Technical Bulletin

Number: FAX-227

Model(s): FO-77
 UX-44 / 66

Subject: Dislocation of Platen Bearing

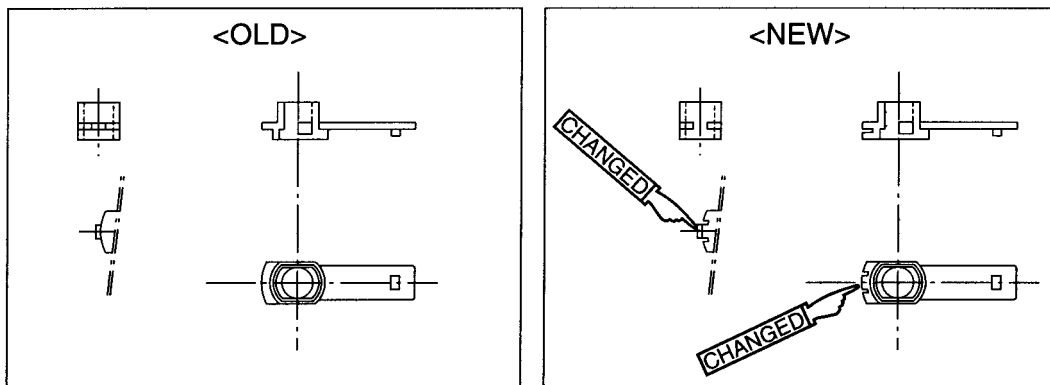
Symptom: The Platen Bearing may dislocate from the frame when dropped or subjected to strong vibration.

Cause: The Platen Bearing shape.

Corrective Action: The Platen Bearing shape has been changed.

**PRODUCTION CUT IN DATE:
 MARCH 2000**
